Attachment 4
Millstone Nuclear Power Station Unit No. 3
License Amendment Request and Technical Specification
Changes For Full Core Off-load
Marked-Up Technical Specification Page(s)

Millstone Nuclear Power Station Unit No. 3
License Amendment Request and Technical Specification
Changes For Full Core Off-load
Marked-Up Updated Final Safety Analysis Report Page(s)

INDEX OF MARKUP OF PROPOSED REVISION

FSAR Figure 3.8.82
Fuel Pool Temperature Transients - Full Core Offload

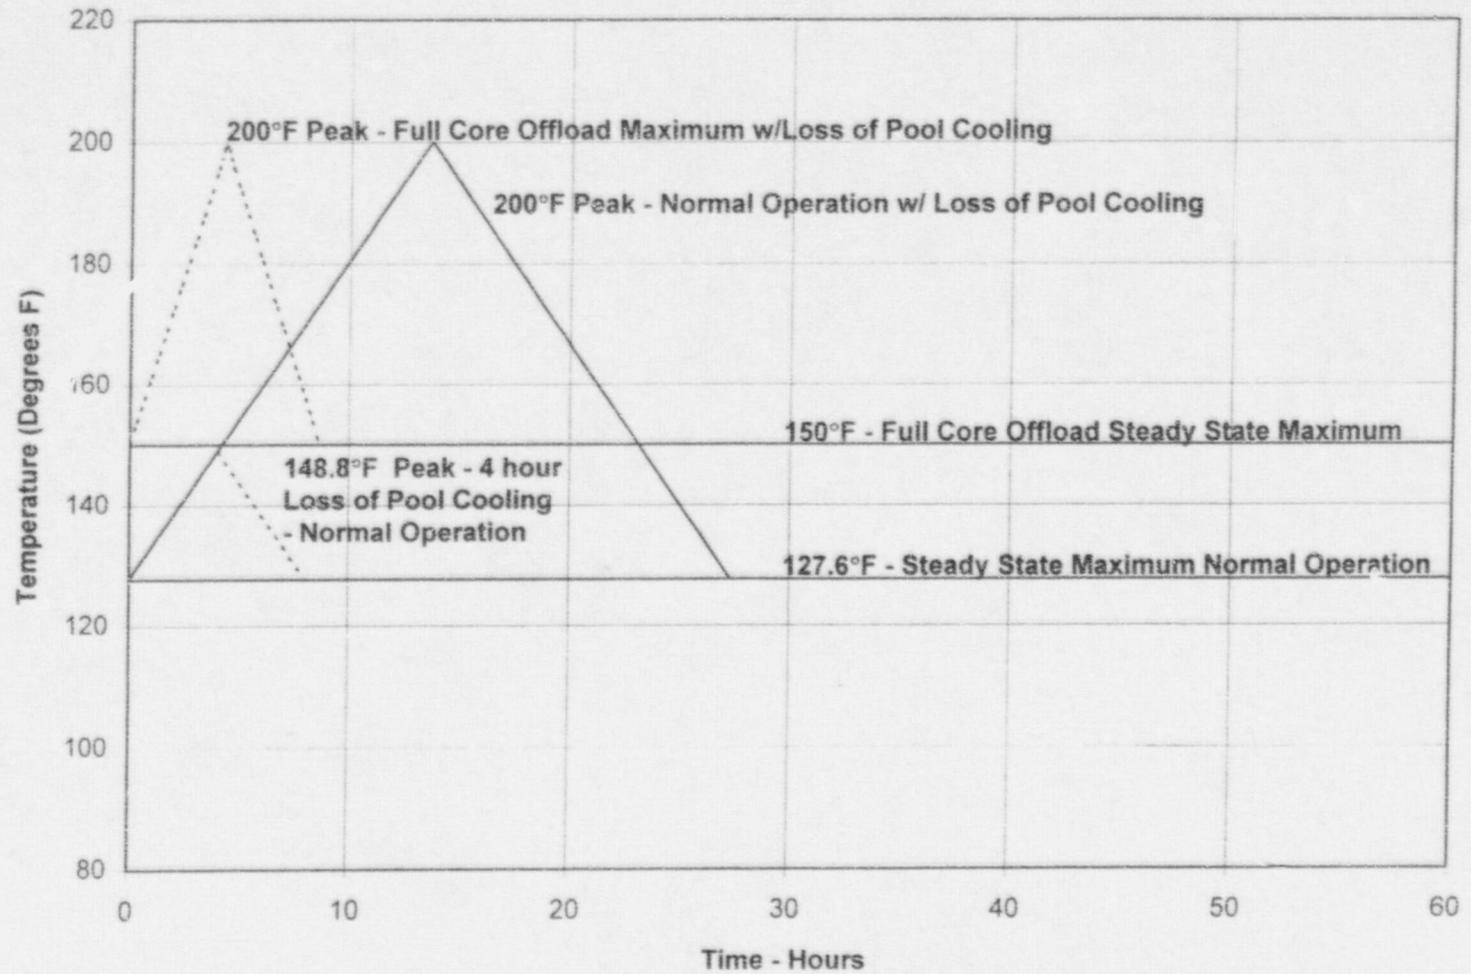
"The historical design of the spent fuel pool walls and mat considered the thermal effects based on the temperatures indicated in Figures 3.8-79 and 3.8-80. The analysis for classifying a full core off-load as a normal evolution evaluated the thermal effects based on temperatures indicated in Figure 3.8.82."

6. Add Figure 3.8.82
7. Appendix 3B, Attachment 1, Appendix E, Environmental Design Conditions: Revised to show the updated environmental conditions associated with a normal fuel temperature of 150°F in accordance with calculation P(B)-1118, rev. 0, CCN 1. Note 1 was revised to show that the expected post LOCA pool temperature transient is enveloped by the transient used to determine the EEQ environment.

FIGURE 9.1-7
 NORMAL REFUELING
 MILLSTONE NUCLEAR POWER STATION
 UNIT 3
 FINAL SAFETY ANALYSIS REPORT

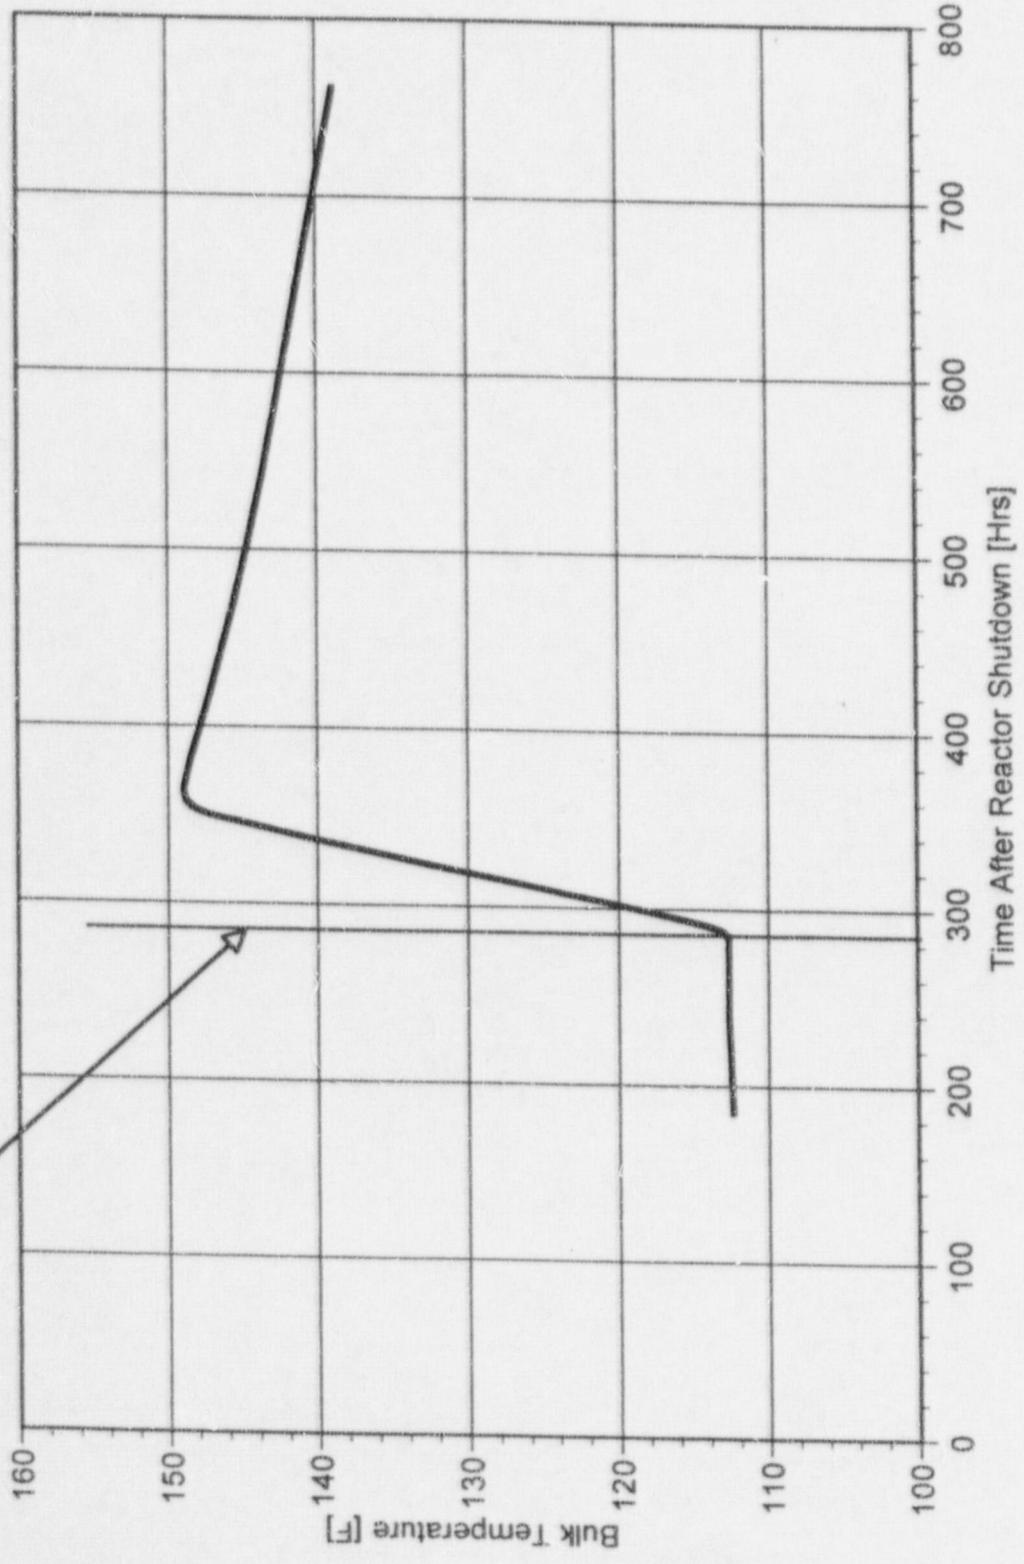
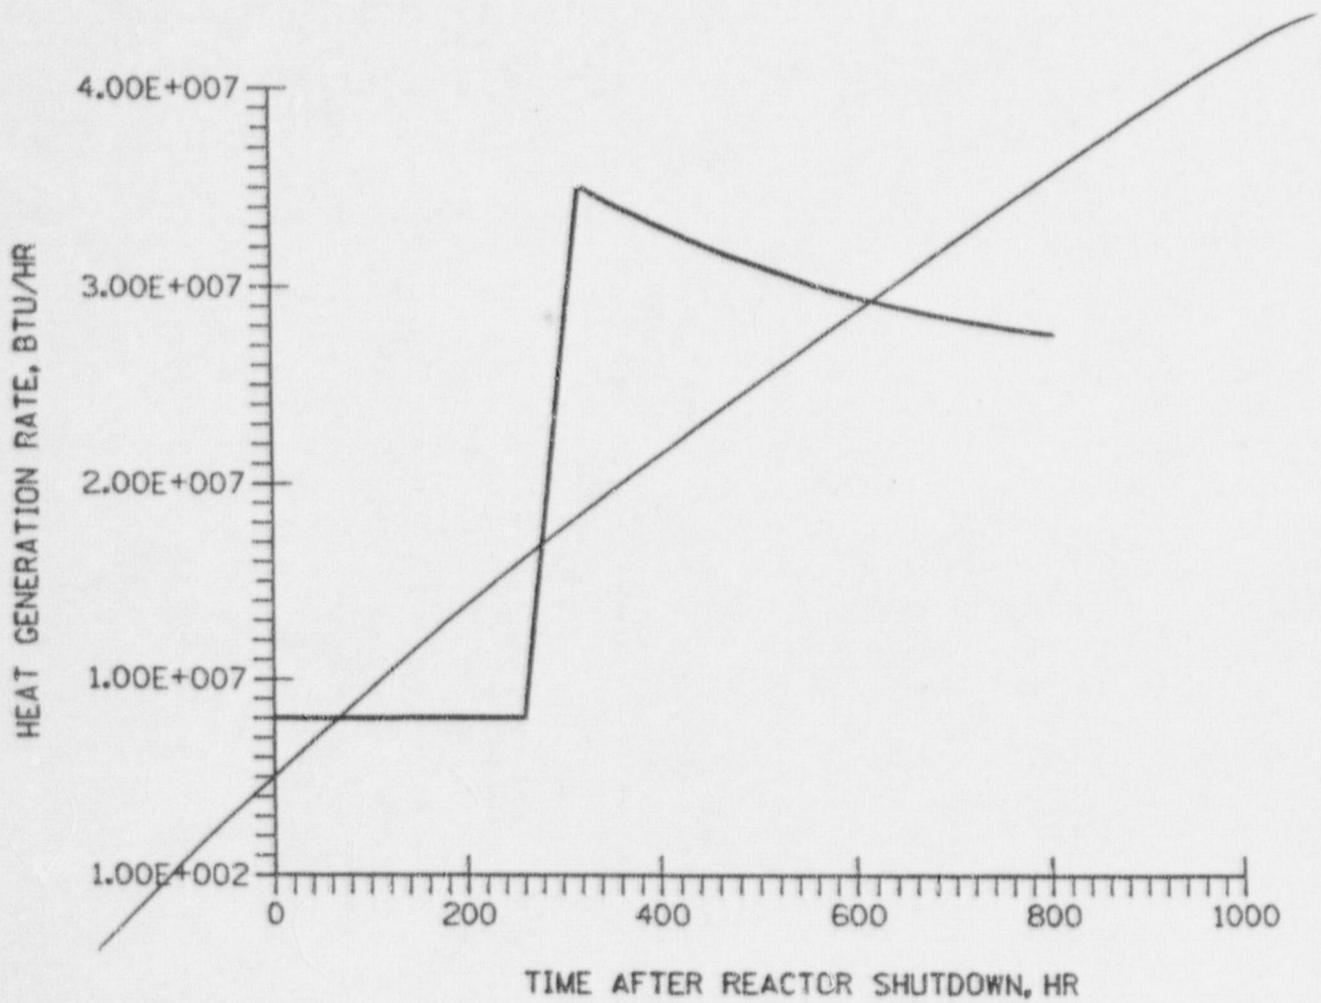
8. Revise the List of Figures as follows:
Figure 9.1-7, delete Title and add "Bulk Pool Transient Temperature Plot (Full Core Offload)"
Figure 9.1-7a, delete Title and add "Bulk Pool Transient Temperature Plot (Emergency Core Offload)"
Figure 9.1-8, delete Title and add "Cooldown Curve for Normal Operation (4 Hours Loss of Pool Cooling)"
Add "Figure 9.1-20, Fuel Assembly Transfer Limit Verses CCP Temperature"

14. Replace Figures 9.1-7, 9.1-7A and 9.1-8 with the attached figures 9.1-7, 9.1-7a and 9.1-8.
15. Section 9.1.3.3, page 9.1-8 & 9, following "These are:" in the fifth paragraph, delete subparagraphs "1.", "2.", "3.", "4." and "Note 1" and replace with the following (Insert C):
